Subject ▶ Change on swash bearing and helical gear

For Models ▶ HR2400 (Rotary Hammer)

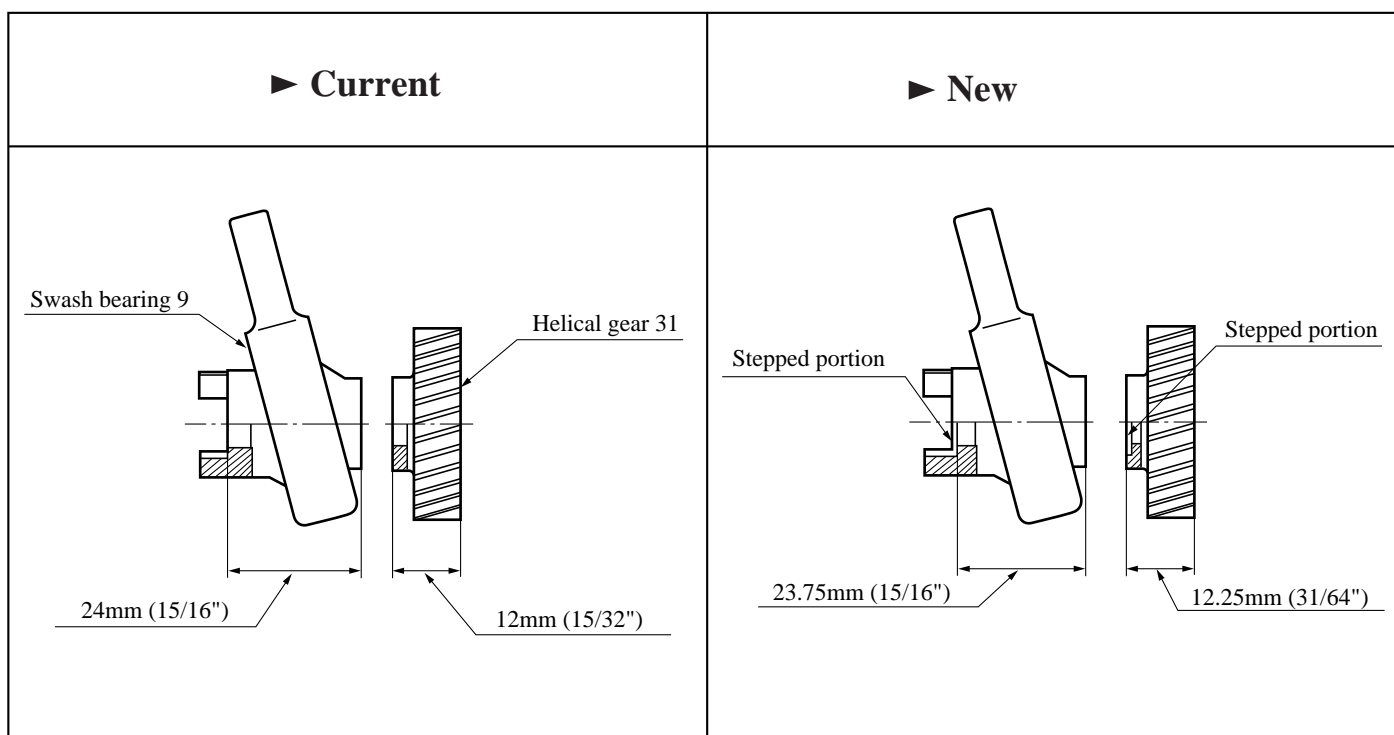
Description ▶ The swash bearing 9 and the helical gear 31 will be changed in their dimensions. The new type swash bearing 9 and helical gear 31 will have a stepped portion to differentiate from the current type.

Item No.	Current part		Q'ty	I/C	New part		Q'ty	Note
031	Swash bearing 9 219004-3		1	No	Swash bearing 9 219007-7		1	Interchangeable as a set
030	Helical gear 31 226410-5		1	No	Helical gear 31 226421-0		1

From serial No. 1240E
